Service Letter

(a) No.:	SL 19
(b) Issue / Date	Issue A / 13-12-2023
(c) Title:	Withdrawal of Parts Support for Vertical Outlet Quick Shut-Off Valve Assembly
(d) Description:	Parts CB-8415-000 - Self Sealing Coupling 7141M Rego Male (3/8 BSP F Thread) and CB-8408-0000 - Tank Fitting QSO Vertical will no longer be supplied by Cameron Balloons Limited.
(e) Applicability:	All types and models using cylinders with vertical outlet quick shut-off valve assembly (VQSO)
(f) Effectivity:	All

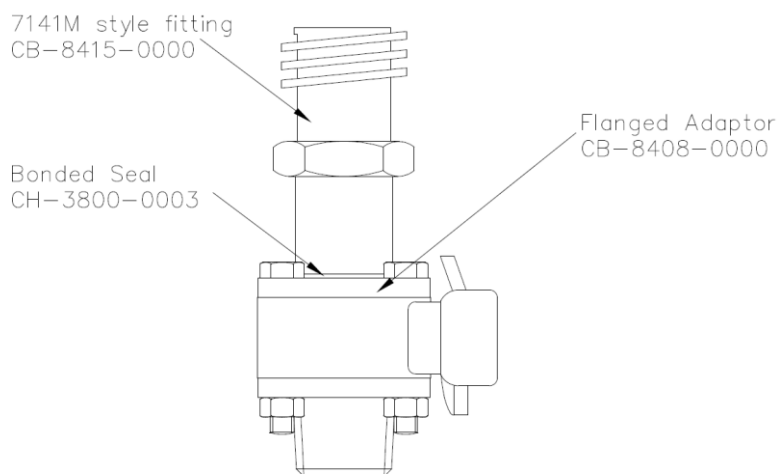
The following parts will no longer be supplied by Cameron Balloons Limited. Cylinders made unserviceable by failure of these parts may be converted to horizontal outlet quick shut-off valve Assembly [Ref: Service Instruction 36].

The CH-7141-0002 coupling **must not** be modified to be used as the outlet fitting for vertical outlet quick shut-off valves.

Cameron Balloons provides no approved data to support the fabrication of part CB-8408-0000; therefore, the CH-7141-0002 coupling **must not** be modified for use as the outlet fitting for vertical outlet quick shut-off valves.
